FINAL
Addendum to the Draft EIR

**OAKLAND - ALAMEDA COUNTY
COLISEUM EXPANSION
Environmental Impact Report**

ER No. 89 - 41
State Clearinghouse No. 89091218

FIGURE 33
CONCEPTUAL PRACTICE FACILITY

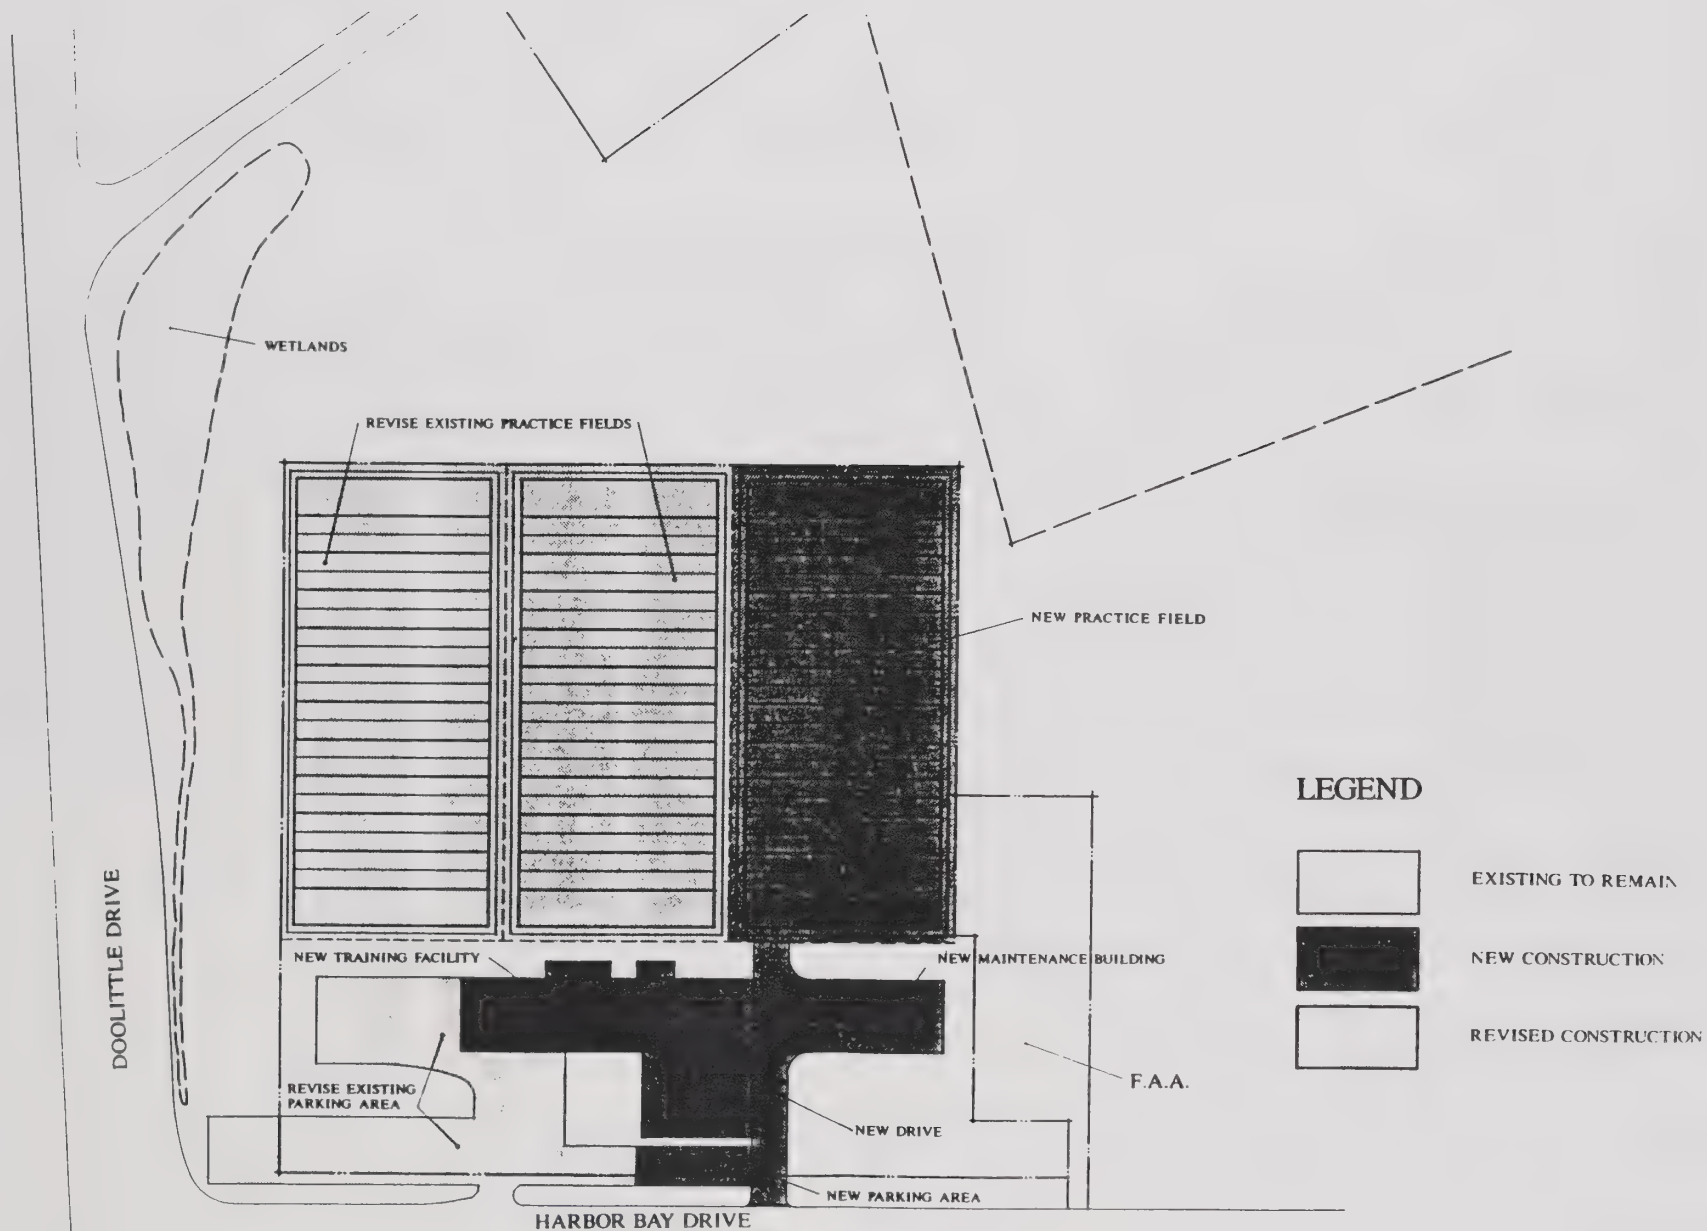
The practice fields, with this alternative, would be reconfigured to avoid the existing wetlands at the southeast corner of the site. The reconfigured practice field would be oriented as shown in Figure 33 (p. 6 herein).

Figure 7 is a schematic site plan. Under the new project description described in Text Changes and Errata, page 3 herein, the practice fields would be reconfigured in a way to avoid potential effects on wetlands. The reconfiguration would likely involve two practice fields in the existing location with the third field set back from Doolittle Drive.

FIGURE 30 (Revised)
WETLANDS IN VICINITY OF PRACTICE FIELDS

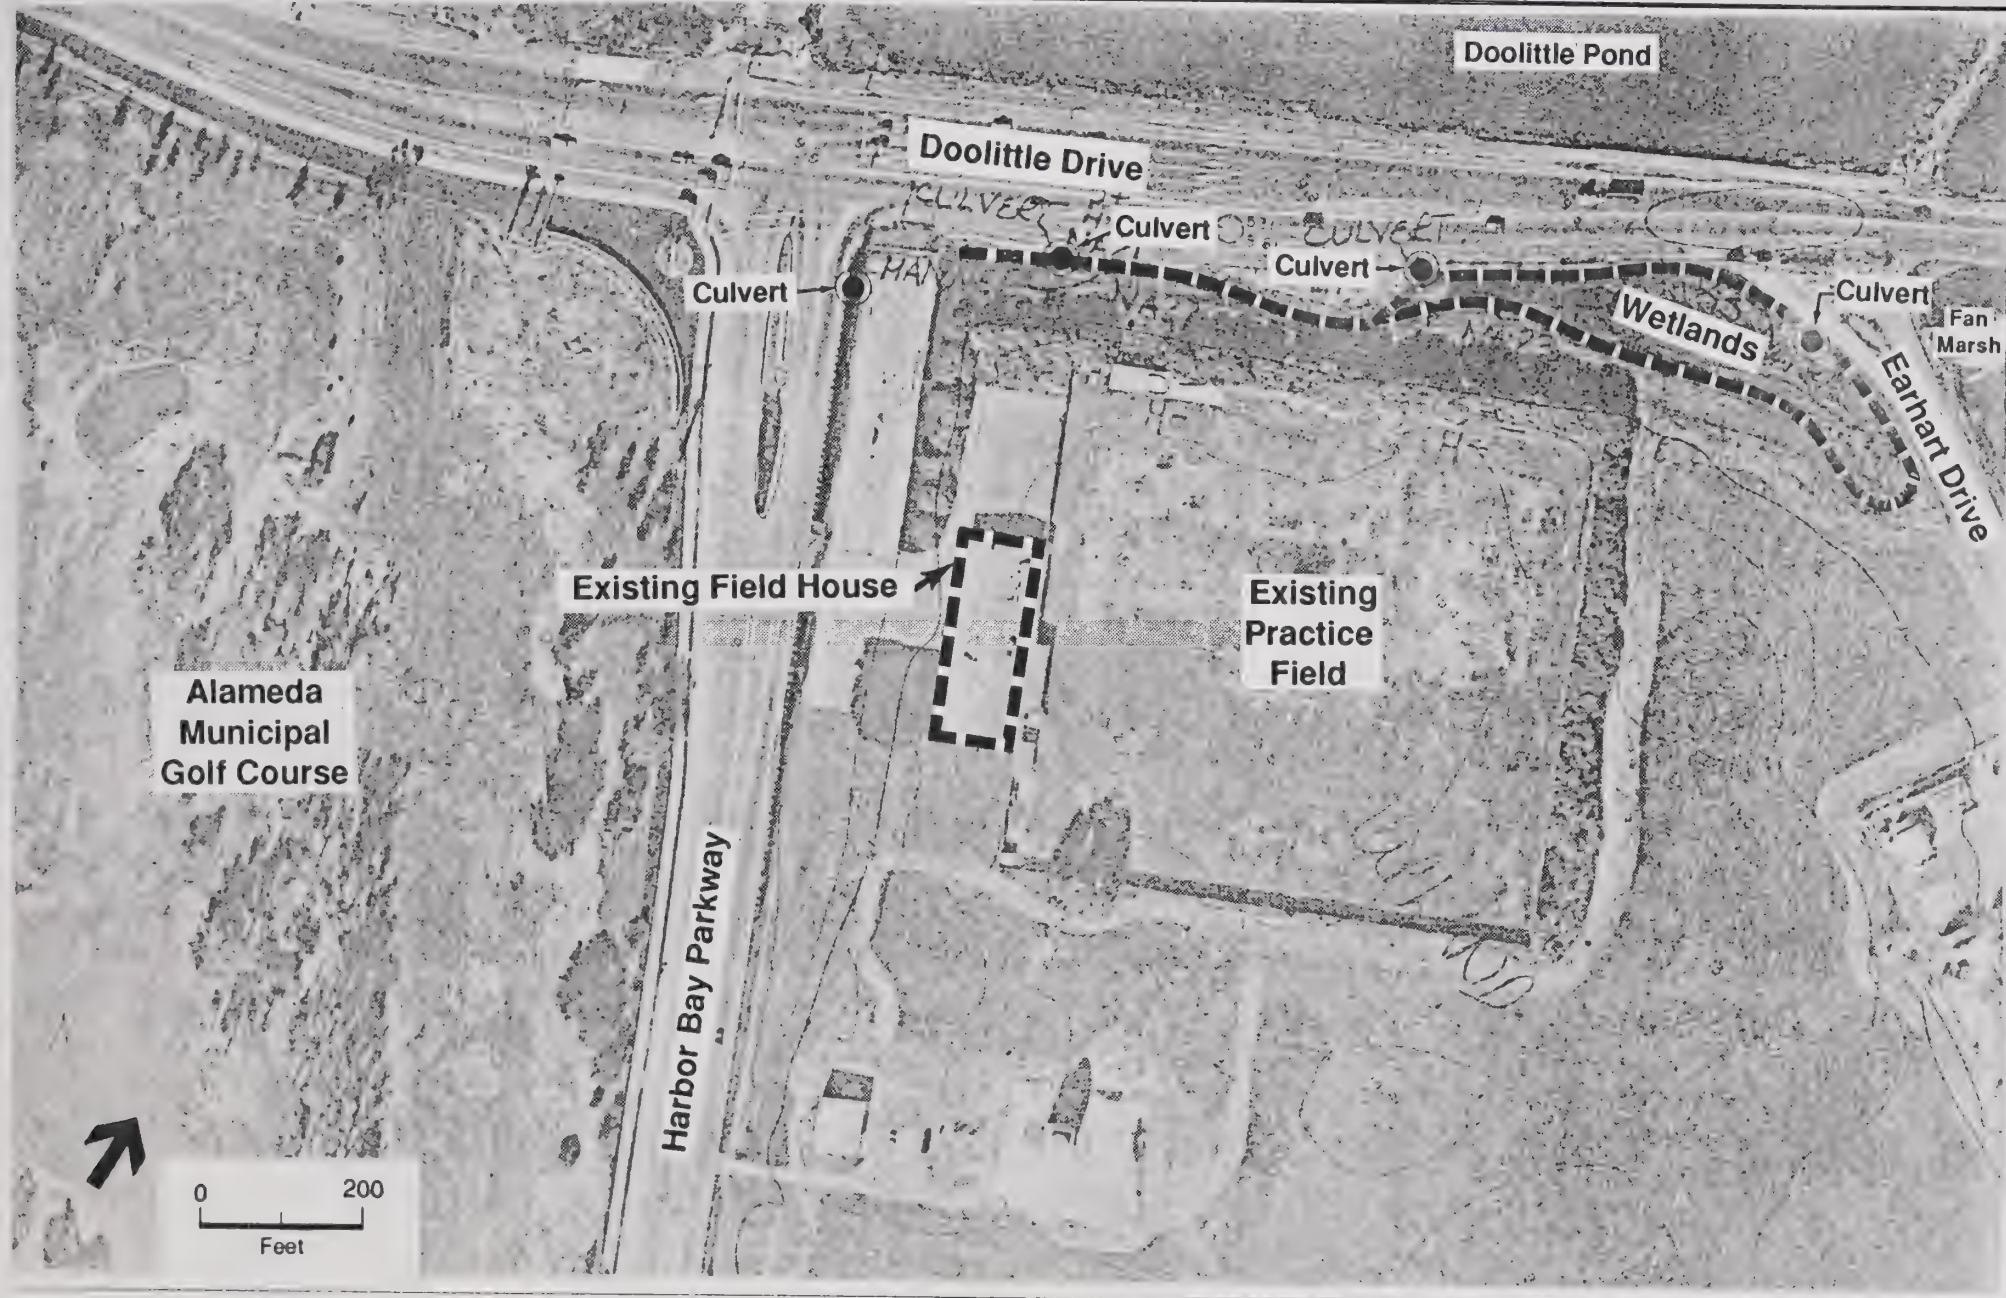
5. Page 132, Figure 30 of the Draft EIR is revised to indicate the correct locations of Fan Marsh and Doolittle Pond.
6. The mitigation measures on page 138 of the Draft EIR are revised to read as follows, to provide measures for both the exterior and interior areas of the project site. Revised language is underlined:

The map on page 132 is incorrect. The area labelled "Fan Marsh" is Doolittle Pond; Fan Marsh is the unlabelled area northeast of Earhart Drive. Also, the proposed playing field site plan does not reflect the actual geographical setting (p. 23). Graphics of the complete existing and proposed project site plan, including the practice fields, presented with the same scale and orientation, would be very helpful.

8. See Text Changes and Errata for corrected Figure 30.
